## Changes in BRCA MASTR v2.1 compared to BRCA MASTR v2.0

- Resulting read counts:

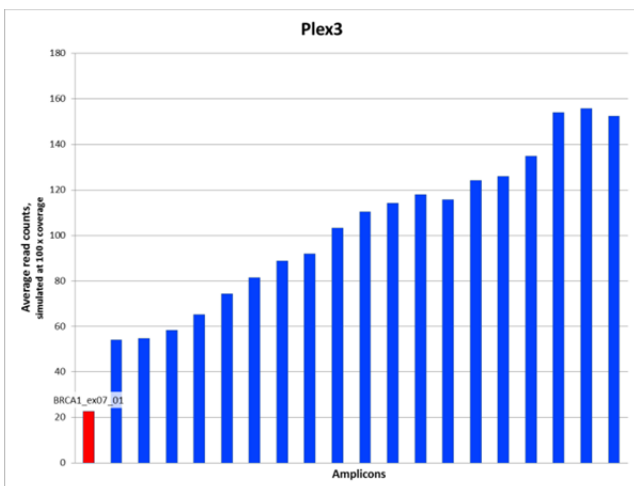
Amplicon BRCA1\_ex07\_01 had the tendency to show low read counts. Detailed analysis revealed this was caused by the combination of a polymorphic GAA-repeat and the presence of a 12bp long poly-A stretch. We opted to ban the polymorphic GAA-repeat from any amplicon and found a solution in which both amplicons for BRCA1 exon7 were replaced by 1 amplicon encompassing the entire exon. Please note that the total number of amplicons is now reduced to 93.

- BRCA1 exon7:
  - BRCA1\_ex07\_01<sup>(v2.0)</sup> is removed from Plex3
  - One primer of BRCA1\_ex07\_02<sup>(v2.0)</sup> is changed, the new amplicon encompasses the entire exon: BRCA1\_ex07\_01<sup>(v2.1)</sup> (Plex4)
  - Figure:

- BRCA2 exon14:
  - One primer of BRCA2\_ex14\_02<sup>(v2.0)</sup> is changed (30 bp more into the intron): BRCA2\_ex14\_02<sup>(v2.1)</sup> (Plex4)
  - Figure:
